Technical Note

Project No: ITB13091
Project Title: Ford Airfield – The Landings
Title: Sustainable Accessibility Addendum Note
Ref: 13091-029
Date: 5 August 2020

TO:	Arun District Council FAO: Raymond Cole
FROM:	Stephen Gee WSCC - Highways Authority
DATE:	17 April 2020
LOCATION:	Land at Ford Airfield Ford, West Sussex
SUBJECT:	F/4/20/OUT Outline planning application (with all matters reserved except for access) for the development of up to 1,500 dwellings (Use Class C3), 60-bed care home (Use Class C2), up to 9,000 sqm of employment floorspace (Use Classes B1), local centre of up to 2,350 sqm including up to 900 sqm retail / commercial (Use Classes A1-A5) and 1,450 sqm community / leisure floorspace (Use Classes D1-D2), land for a two-form entry primary school (Use Class D1), public open space, allotments, new sports pitches and associated facilities, drainage, parking and associated access, infrastructure, landscape, ancillary and site preparation works, including demolition of existing buildings and part removal of existing runway hardstanding. This application affects a Public Right of Way. This application is the subject of an Environmental Statement. This application falls w

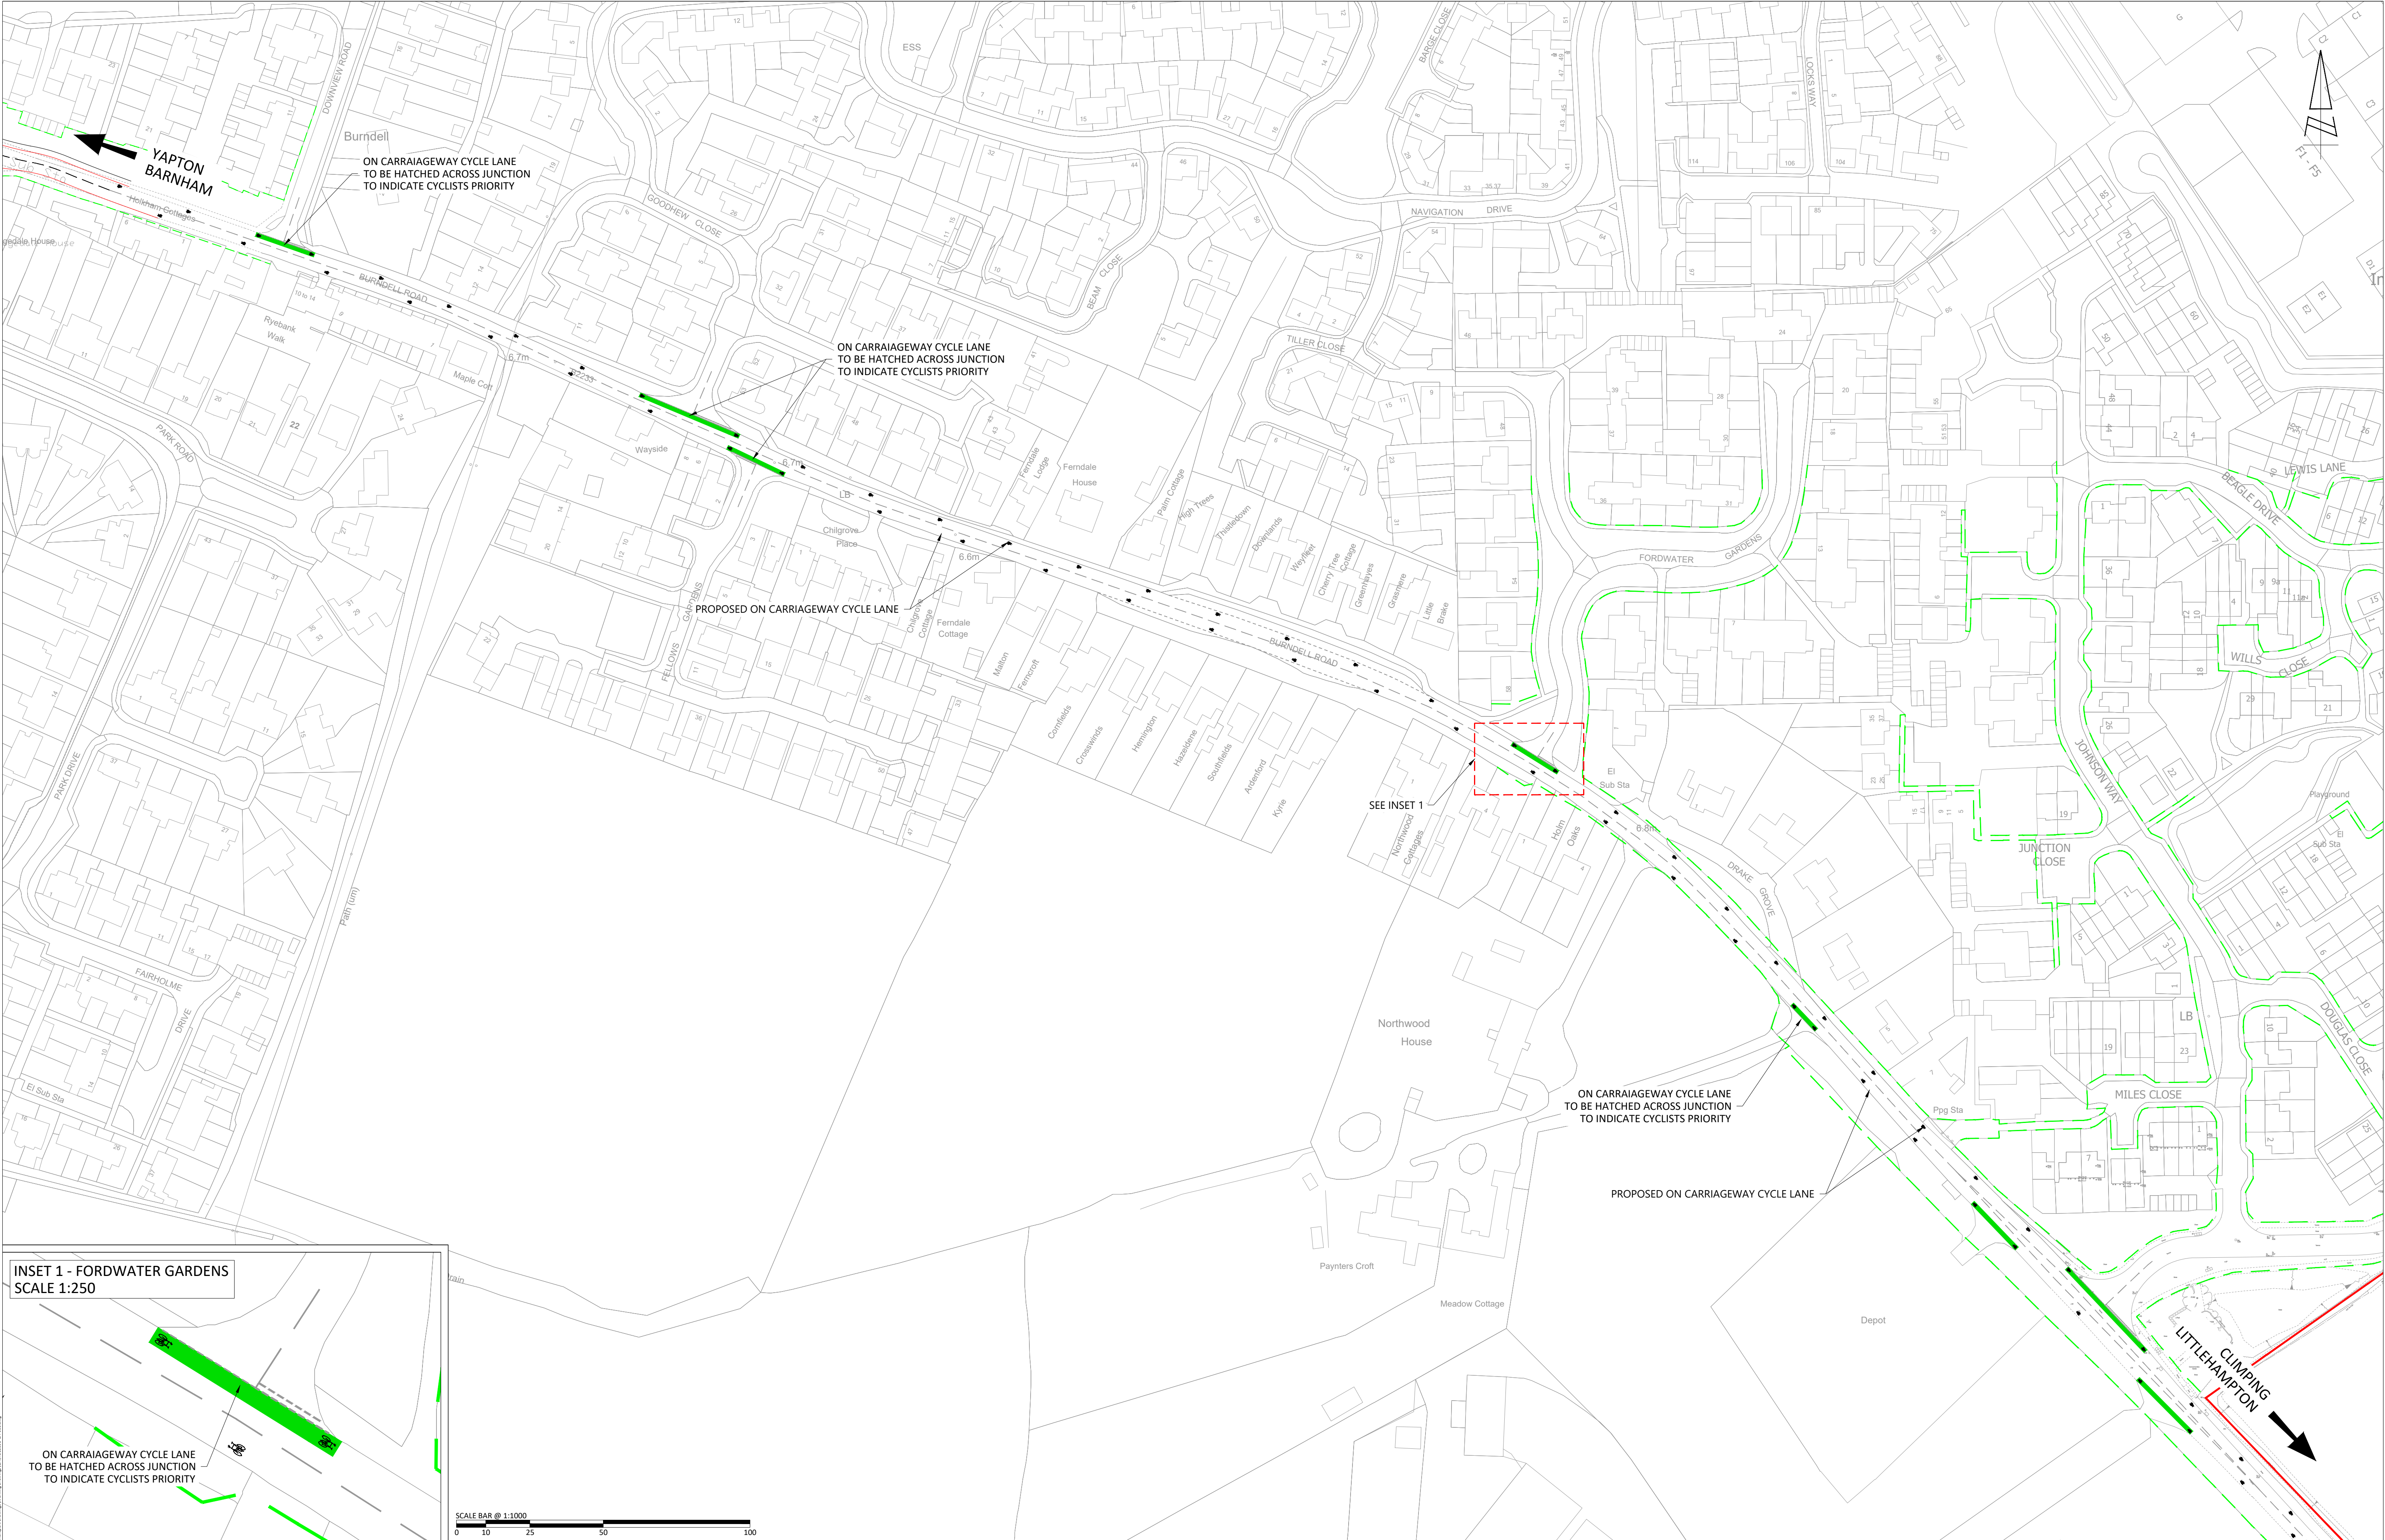
- 3.1.1 WSCC has requested that further consideration be given to provision of cycle facilities between the development site and Yapton.
- 3.1.2 It is not possible to provide an off-road route along the B2233 due to width constraints along the corridor as a result of private property being located on both side of the road. As recognised in Chapter 3 of the CDG, it is recognised that it will not always be possible to retrofit new infrastructure into the existing highway network in accordance with the design guidance contained within the document due to such constraints. The CDG advises that, in such instances, the design should be considered on a site-specific basis.

- 3.1.4 On this basis, a scheme of improvements has been prepared and are shown in **Drawings ITB13091-GA-059, 060 and 061**. The scheme comprises signage of a cycle route to Yapton from Rollaston Park with on-carriageway cycle logo demarcation situated 1.5m from the kerb at 25m intervals. In addition, green coloured surfacing is provided across junctions to reinforce the potential presence of cyclists and minimise the risk of conflict arising from vehicles overshooting the give-way line/creeping into the carriageway from a side road.

- 3.1.6 At this time no signage has been shown along the route, as the directional signage would be affected by the onwards facilities available at the time of implementation. However, an illustrative sign is shown in Drawing **ITB13091-GA-061** to define the type of signage that would be included along the route.

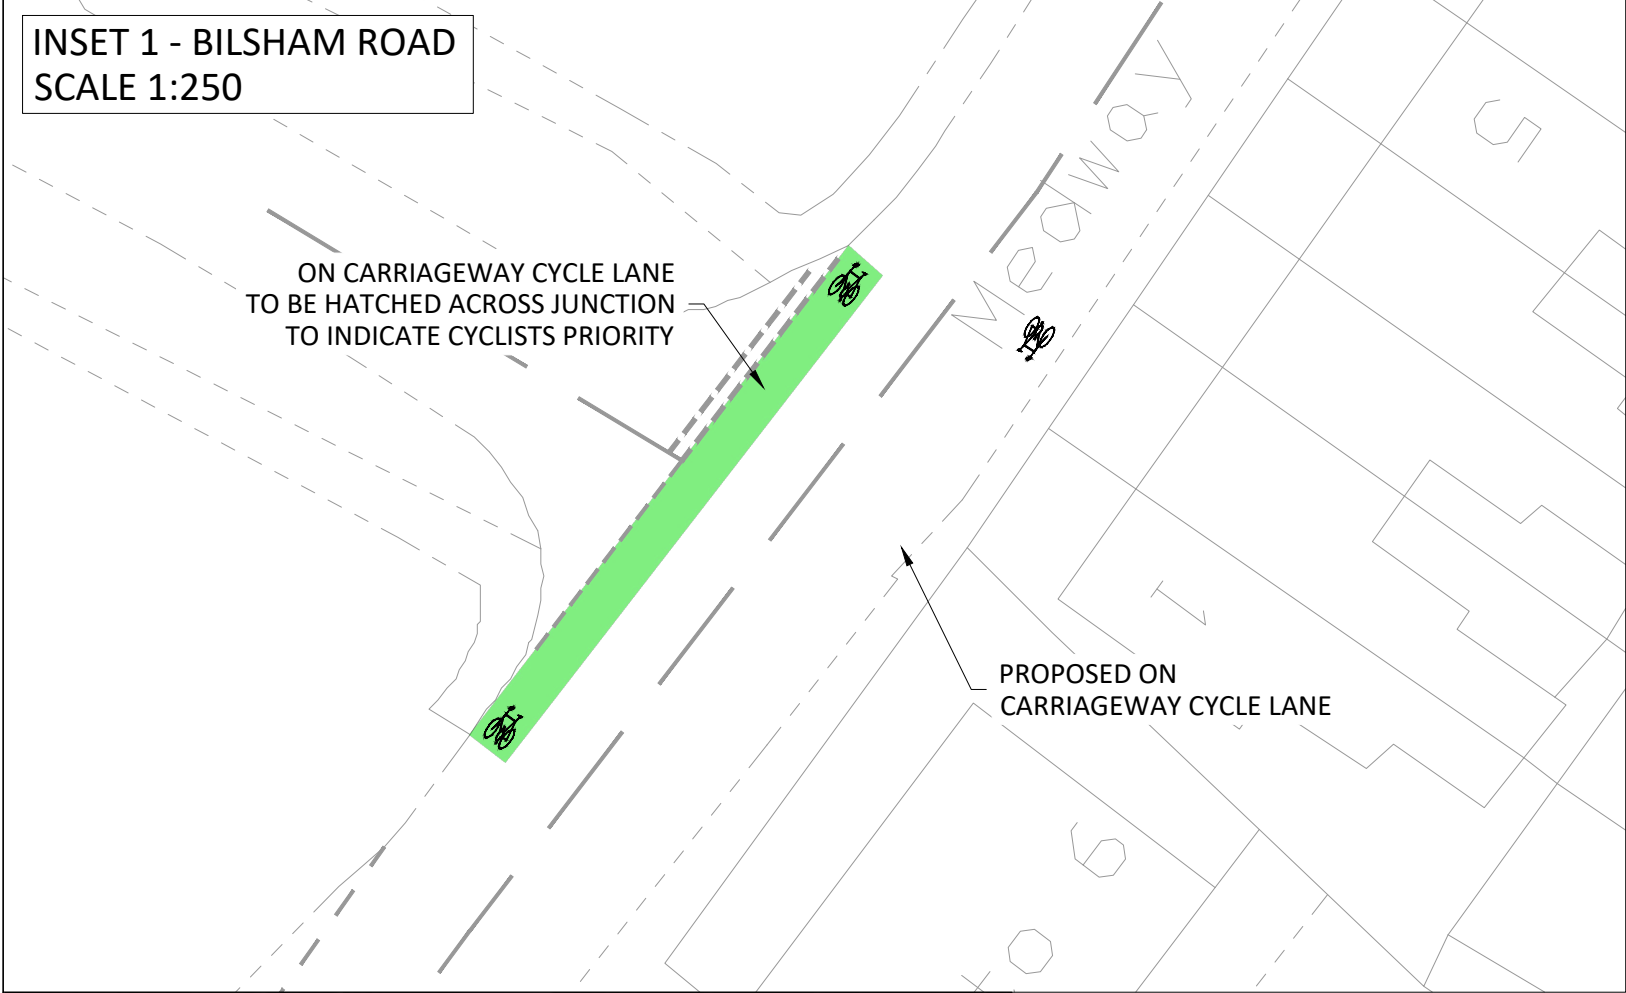
- 3.1.3 The B2233 is subject to the carriage of buses services and therefore it is necessary to retain a carriageway width of at least 6m in order to effectively accommodate these services; in doing so, it would only be possible to provide cycle lanes circa 1m in width. Table 2a of the CDG sets out that a width of 1.7m would be required to provide for an absolute minimum effective width of 1.5m. In such circumstances, the CDG advises that where the minimum width cannot be attained over the majority of its length then cycle lanes should not be provided. Alternatively, cycle signage and demarcation should be used.

- 3.1.5 The scheme of improvements has been shown to extend from Rollaston Park in the east to Yapton Village Hall in the west, directly west of the Bilsham Road/B2233 mini roundabout. In addition, the route extends south from the Bilsham Road/B2233 mini roundabout to Mill View Road to provide a connection to potential onwards facilities secured through planning consents Y/91/17 and Y/92/17.
